STAFF REPORT

REFERENCE: RM070685

SUBJECT: **LAMB CONTRACTING LIMITED - REPORT EP08/07/02** - Report prepared for 14 July 2008 Hearing

PROPOSAL: Section 357 objection to Condition 2 of Resource Consent RM070685

Figure 1: Aerial photograph of the site with significant features marked

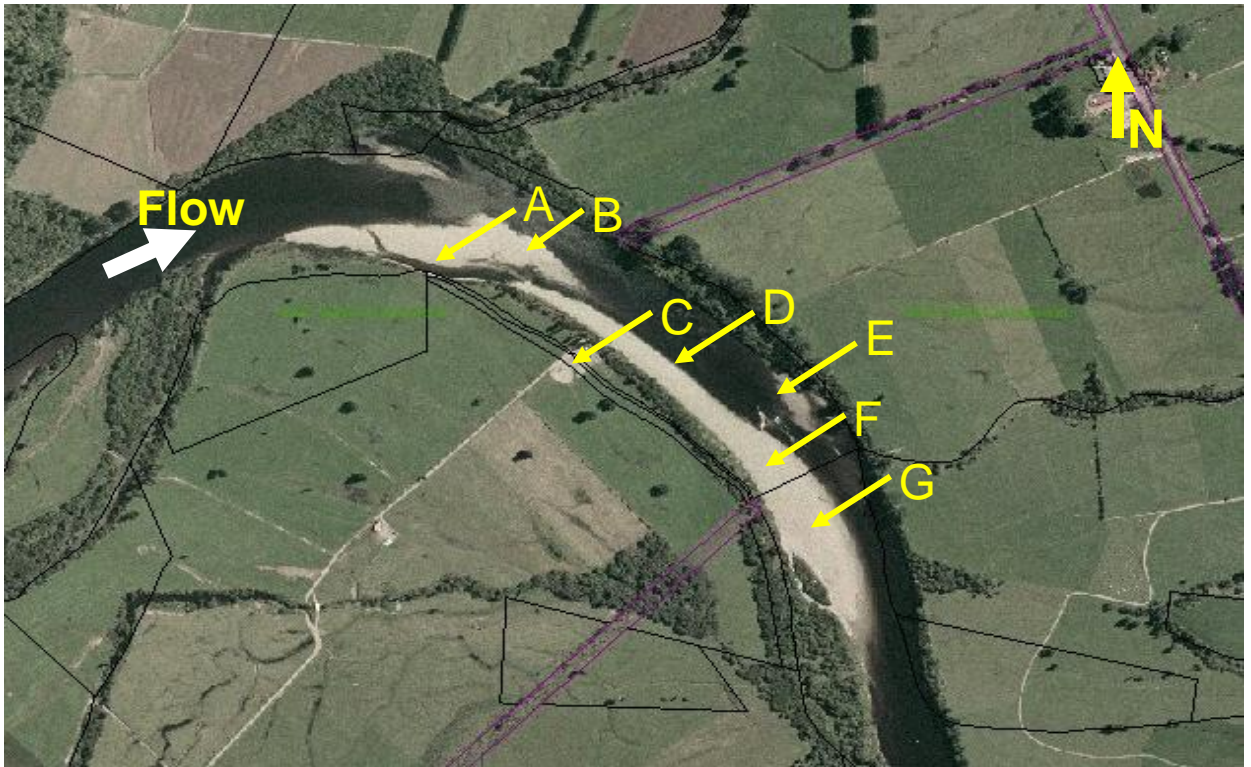
- A Evidence of erosion against the true right bank
- B Gravel bar with some deposition evident
- C Extracted gravel stock plied
- D Lowered riverbed showing signs of recent extraction
- E Shallow rapids
- F Low-lying beach just above low flow water level
- G Inside of meander with some deposition evident

When in December 2007 staff visited the reach in question there was no sign of recovery of at least part of the extraction site, and this would not recover if deposited material at the upstream end of the reach were to be removed. With respect to flow direction, flows will always concentrate on the outside of bends, in this case the left bank. Rock protection on the left and right bank is more likely to be indicative of bed degradation than river flow deflection by major bar and beach complexes.
